Subject: Response to the U.S. Environmental Protection Agency Letters Dated February 27, 2015 and June 5, 2015 Regarding the 2014 Compliance Recertification Application

**EPA Comment****2-46-1 CCA Appendix WRAC Waste Removal Documentation Needs Updating.**

**Title 40 CFR Part 191  
Subparts B and C  
Compliance Recertification Application 2014  
for the  
Waste Isolation Pilot Plant**

This Appendix is a revised version of the Compliance Certification Application (CCA) Appendix WRAC (DOE 1996). The revision to Appendix WRAC was made in response to Environmental Protection Agency (EPA) completeness comments on the 2014 Compliance Recertification Application (EPA 2015).

Figure WRAC-5. SWB and Seven-Pack Configurations

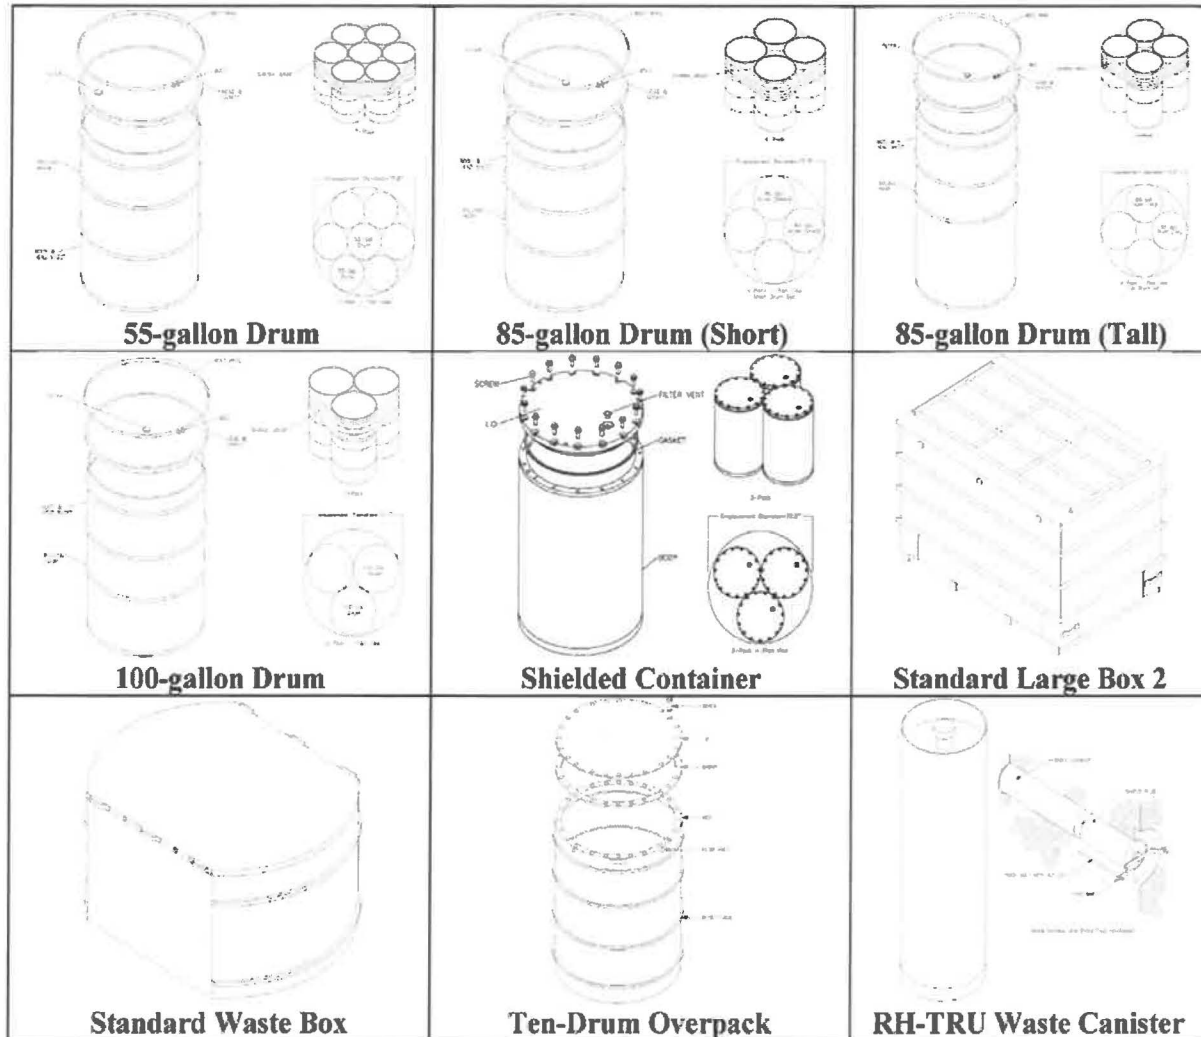
- *The waste containers have changed. The CCA assumed two principal types of containers (55-gallon drums and standard waste boxes) [CCA Appendix WRAC, page WRAC-8] but with the introduction of large waste boxes, shielded RH-TRU containers, pipe over packs, and super-compacted waste, these assumptions are no longer valid.*

See revisions to Section WRAC-5.0, page WRAC-8, lines 7-15, and Tables WRAC-1 and WRAC-2. See also Figure WRAC-5, Section WRAC-5.3, page WRAC-14, lines 13-17, and Section WRAC-7.0, page WRAC-18, lines 1-11.

Figure WRAC-6. WIPP Repository at Time of Closure

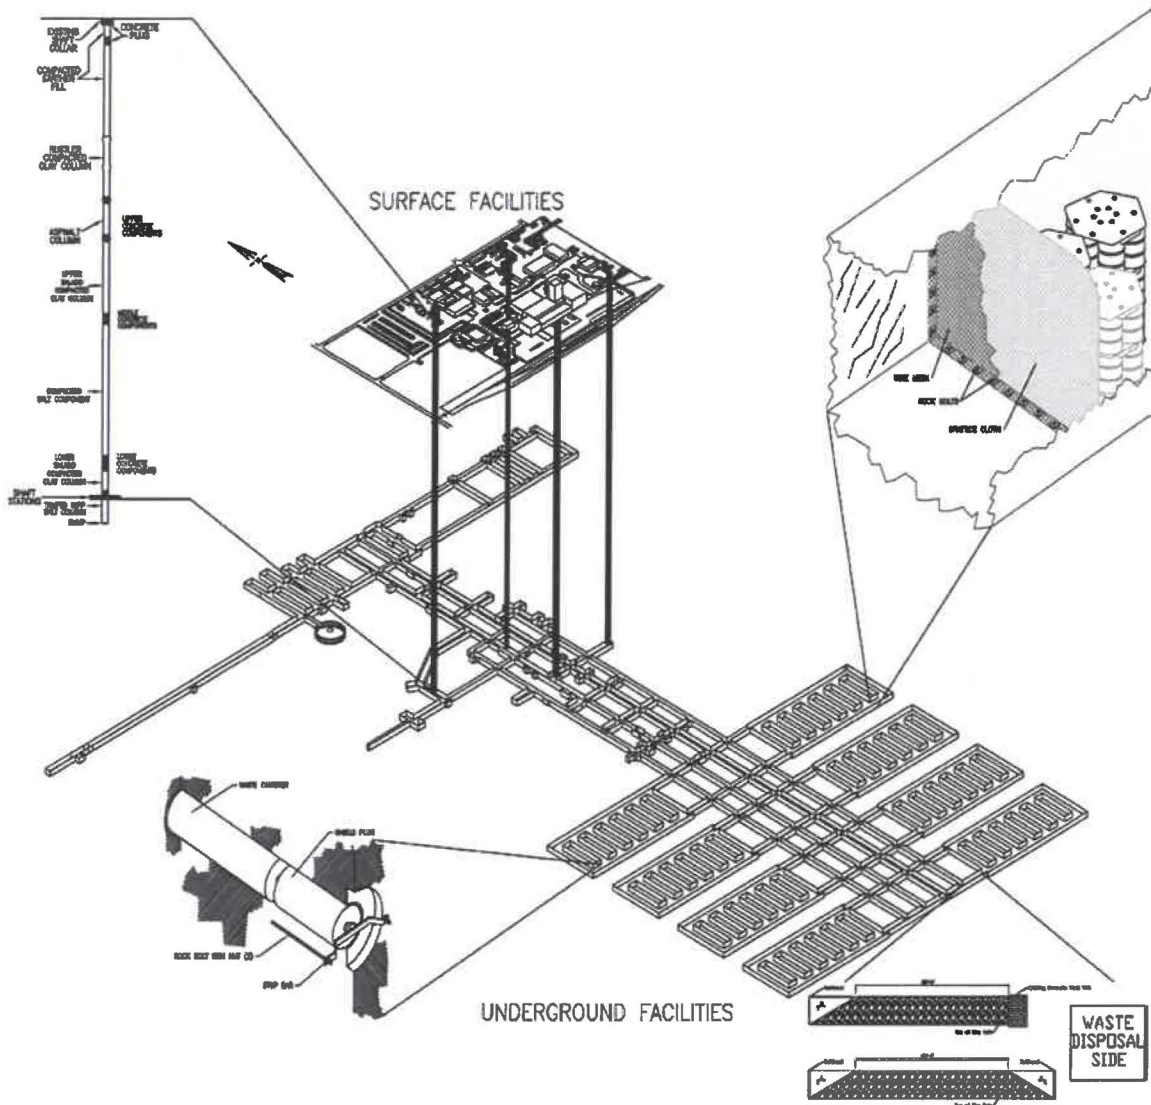
- *The waste characteristics have changed with the introduction of nitrate waste potentially subject to exothermic reactions.*
- *The run-of-mine salt panel closure replaced the original concrete-based Option D panel closure design, which can no longer be used "as markers for locating panels and drifts" [CCA Appendix WRAC, Section WRAC.6.4].*

See revisions to Section WRAC-5.0, page WRAC-8, lines 19-23; text concerning the Option D closure has been deleted. See also Figure WRAC-6.
